Technical Service Bulletin: tsb101240

Released Date: 22-Jan-2003

Jacket Water Cooling Circuit Improvement

Figure 1, New Arrangement (Right Bank)

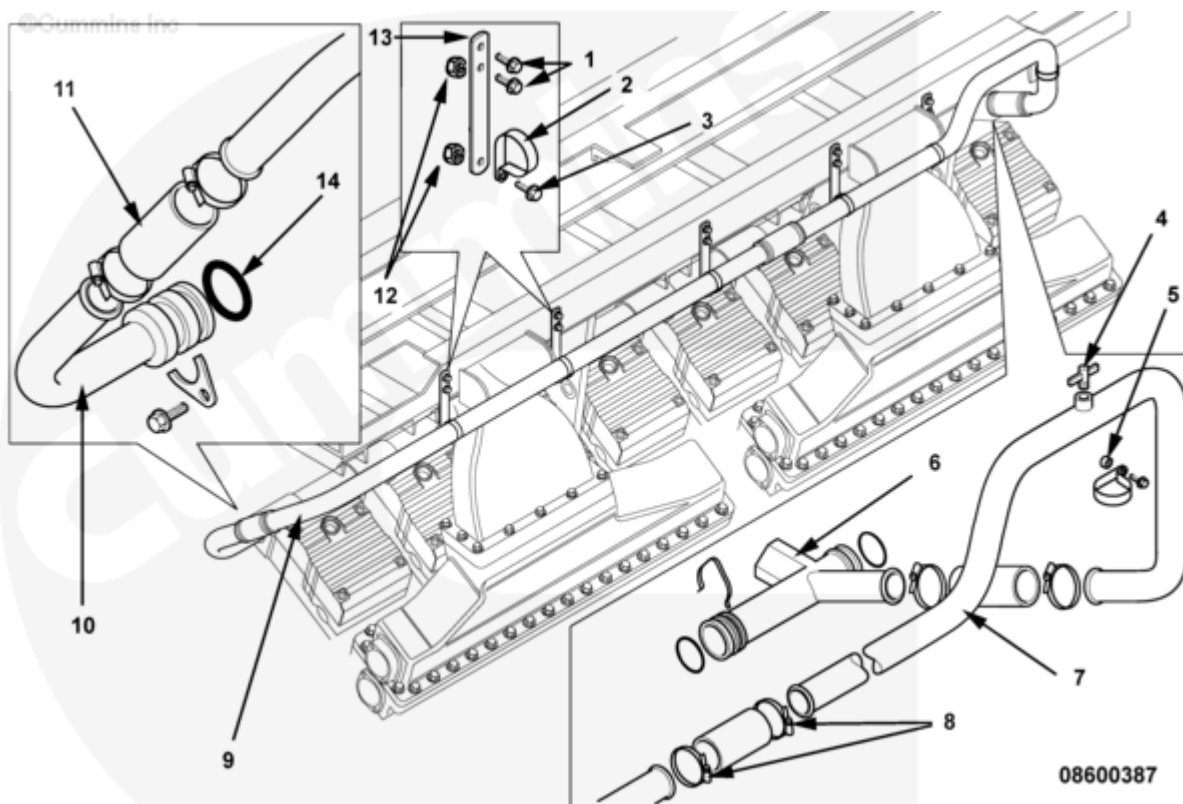
This Service/Parts Topic announces an improvement to the jacket water cooling circuit on QSK60 engines with 2-stage turbocharging. The intent of the design change is to increase coolant flow around the right bank cylinder liner number 8, resulting in greater cooling and ultimately extended piston ring life. This is achieved with the addition of a loop in the cooling system which balances the coolant flow between the right bank cylinder number 1 and cylinder number 8.

This coolant loop is unique to QSK60 2-stage engines because the coolant supply for the intercoolers is located near the right bank cylinder number 8.

It is recommended that the right bank cylinder number 8 coolant loop is fitted at engine rebuild.
